ADDENDUM NO. 3

DATE: November 24, 2025
FROM: City of Grand Junction Purchasing Division
TO: All Offerors
RE: D ½ Road Capacity Improvements IFB-5755-26-DD

GOLDPRO STORM™ DUAL-WALL HP SPECIFICATION

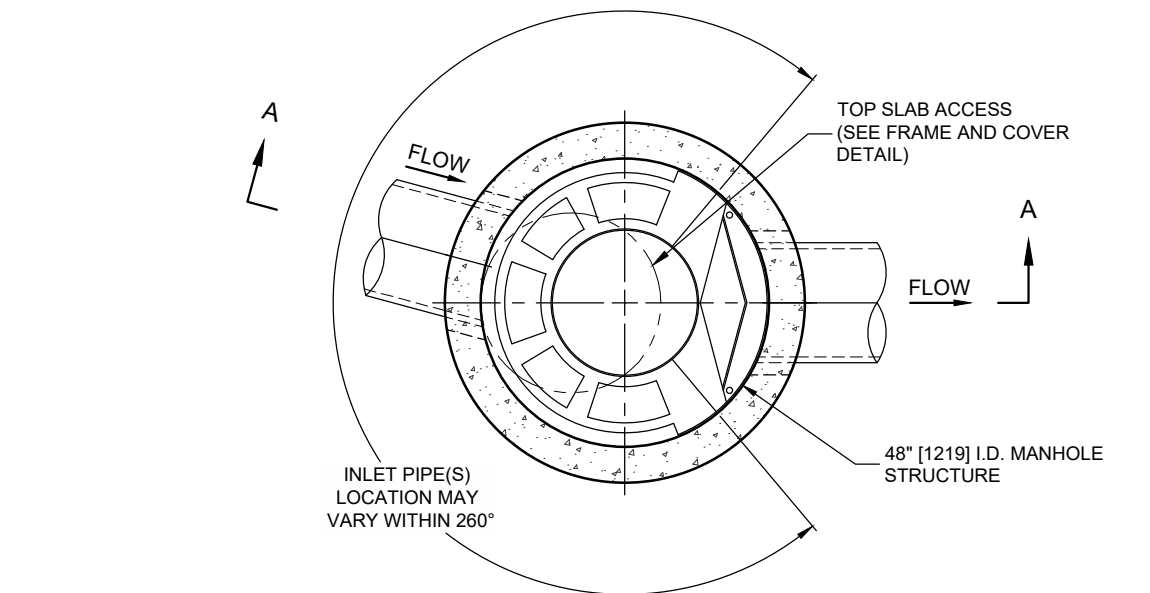
1. Question: Will Prinsco GoldPro Dual Wall Polypropylene be an approved equivalent to the RCP called out on the bid schedule? Attached are the specification sheets and the CDOT APL reference for your review.

Answer: Prinsco GoldPro Dual Wall Polypropylene is approved as equivalent to the RCP called out on the bid schedule. Please note that there is a quantity of owner-supplied RCP that should still be accounted for and would not change material type. All manufacturer requirements, including but not limited to cover and compaction requirements should be followed for placing the equivalent material.

CS-4
CASCADE SEPARATOR
STANDARD DETAIL

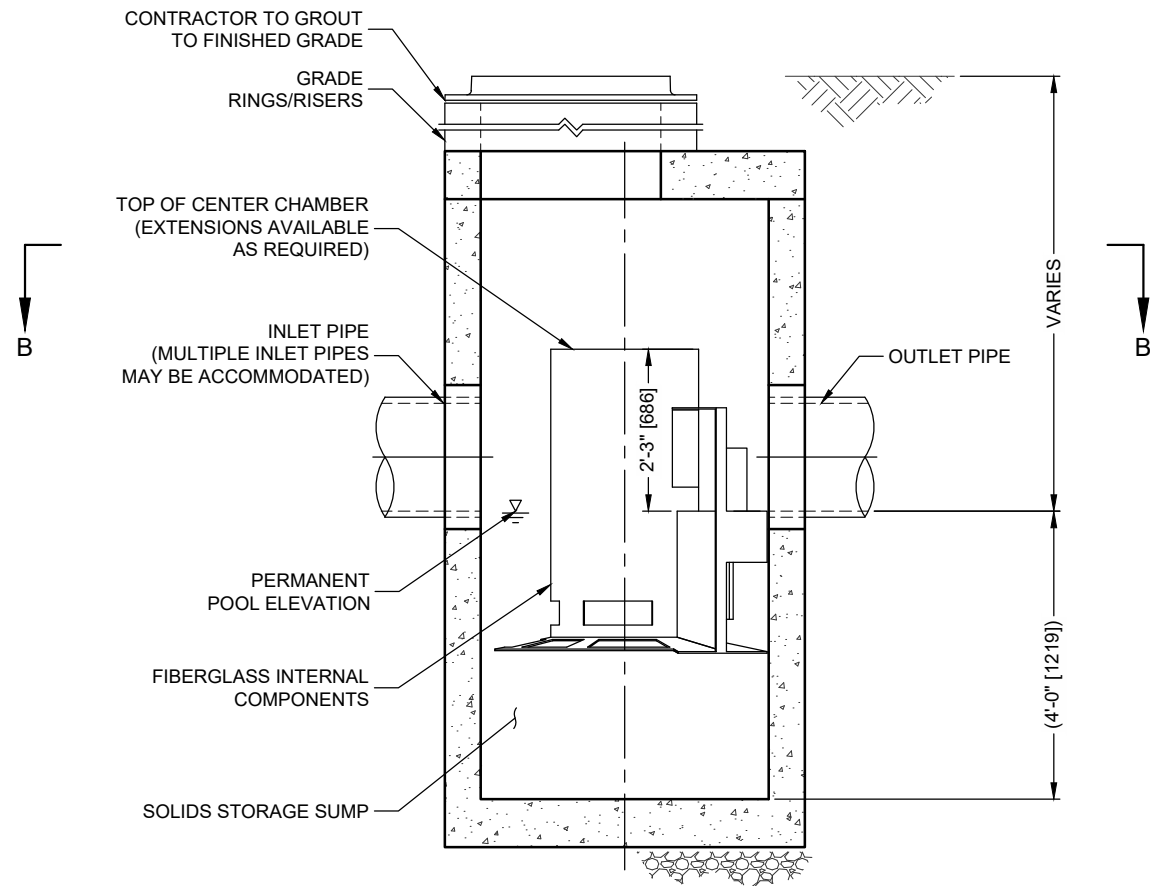
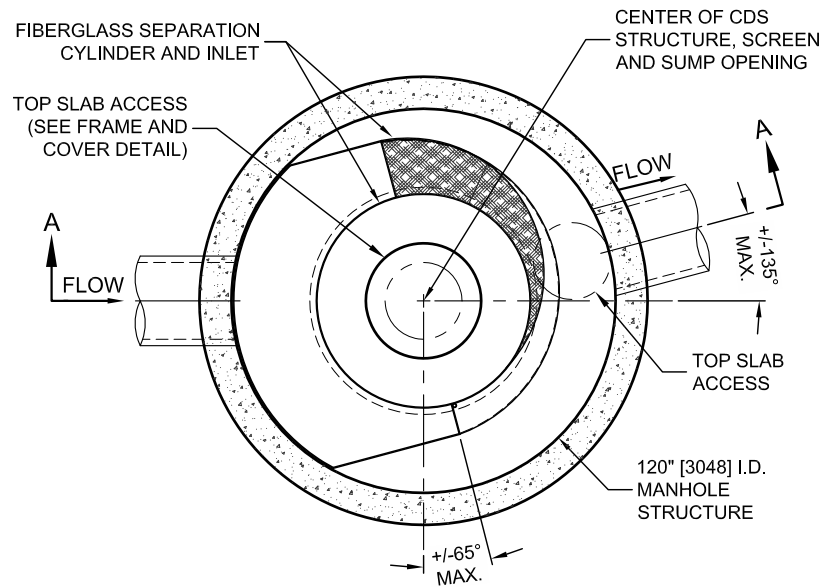
2. Question: Will the Contech CS-4-DTL be an approved equivalent to the ADS Barracuda S4 Water Quality Manhole? Attached is a specification sheet for your review.

Answer: More information is needed. Special Provision 13 specifies the 2-year event (WQCV Design Event) and the 100-year event flow rates. Any approved equal needs to meet the treatment criteria for these storm events. Additionally, a Barracuda S4 is not the structure proposed by the design. ADS Bay Separator 10K was modelled by the design firm.

CDS5653-10-C
INLINE CDS
STANDARD DETAIL

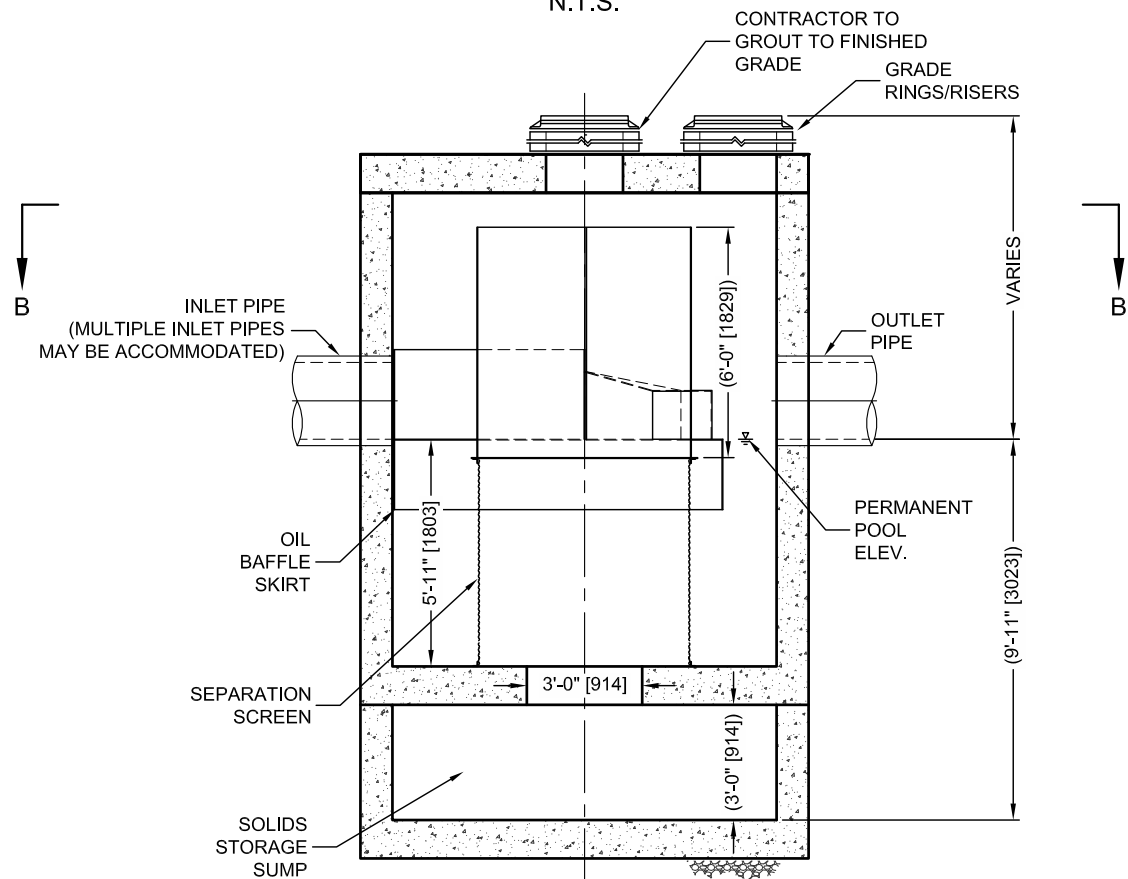
3. Question: Will the Contech CDS 5653-10-C be an approved equivalent to the Arcadia AR4PC Water Quality Manhole? Attached is a specification sheet for your review.

Answer: More information is needed. Special Provision 13 specifies the 2-year event (WQCV Design Event) and the 100-year event flow rates. Any approved equal needs to meet the treatment criteria for these storm events.
